# Corktown Transit-Oriented Community Public Engagement Final Summary Report

**Virtual Event  
(December 6, 2021)**

Figure 1: South Site, West Building Update

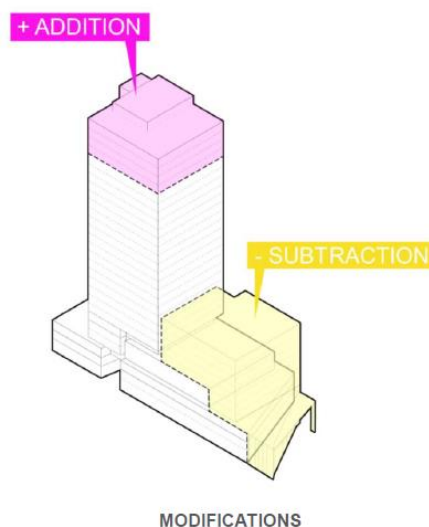
- In response to public feedback asking for an expanded park, the proposed park addition on the South site adjacent to existing Parliament Square Park has been expanded from 810 sq. m to 2,133 sq. m.

- The height and massing for the East Building and West Building have been modified to accommodate the park's expansion.
  - Additional storeys were added to replace the floor area that was subtracted in order to accommodate the increased proposed parkland (Figures 1 and 2).

- The residential tower on the East Building was increased from 25 to 30 storeys. The office tower on the West Building was increased from 24 to 28 storeys.

Figure 2: South Site, East Building Update

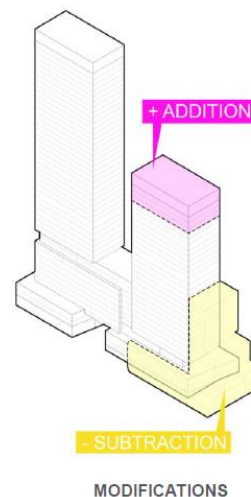
- The library was relocated to the East Building along Parliament Street. In addition, the total area of institutional space has been increased to accommodate an approximate 2322 sq. m (25,000 sq. ft.) library and an approximate 465 sq. m (5,000 sq. ft.) heritage interpretation space.

Figure 3: South Site, Integrated Library and Heritage Interpretation Space

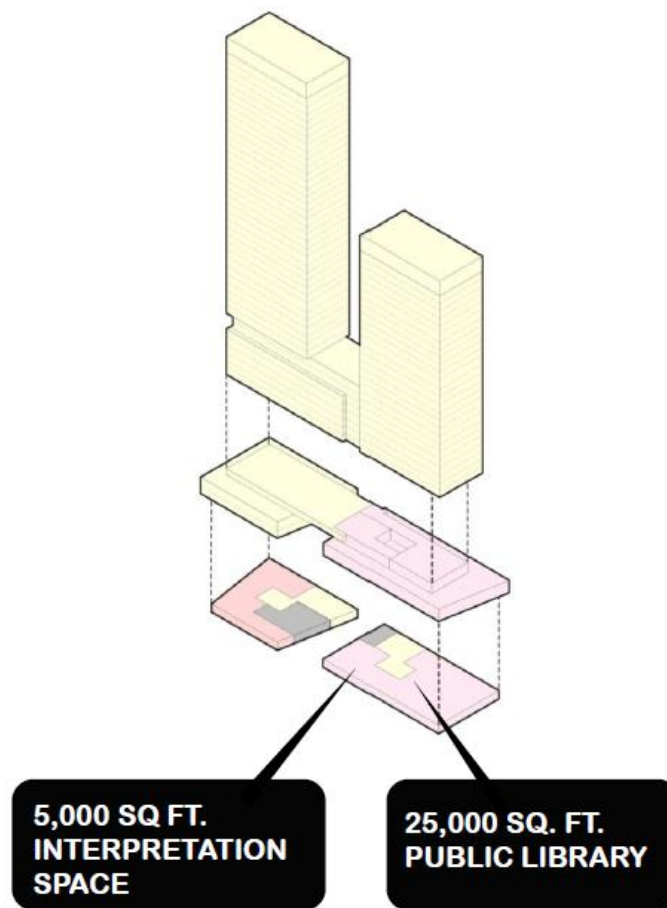
A responder asked which organization was conducting archaeological research of the First Parliament site and if the onsite excavations are for their research. The Project Team informed the responder that Metrolinx is responsible for the archaeological work and registered archaeologists are actively working onsite to support this work. Responders were generally curious about the commemoration and heritage aspects incorporated into the TOC concept. The Project Team agreed that heritage and commemoration are important aspects of the TOC and to the community. In the revised concept on the South site, 5,000 sq. ft. of interpretation space has been integrated with the new library for commemoration, education, and other uses to be determined as the design develops (Figure 3).

Figure 4: Expansion of Parliament Square Park

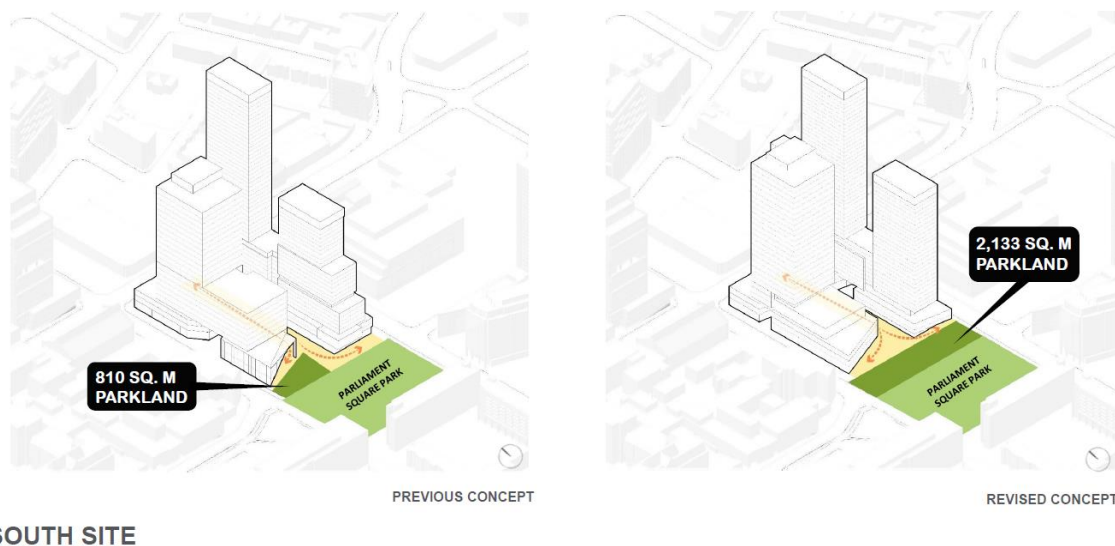
A responder asked why the proposal removed 1,300 sq. m of zoned parkland from the community that was being planned for through the King-Parliament Secondary Plan. The Project Team explained that they are meeting the City's requirements for parkland dedicated space onsite. In the revised concept, the Parliament Square Park addition

has been expanded from 810 sq. m to 2,133 sq. m (Figure 4) in response to conversations with the City and feedback from responders and the Local Advisory Committee (LAC). The 2,133 sq. m is provided based on the City’s alternative parkland rate calculated to meet the needs for the anticipated residents and employees of the TOC.
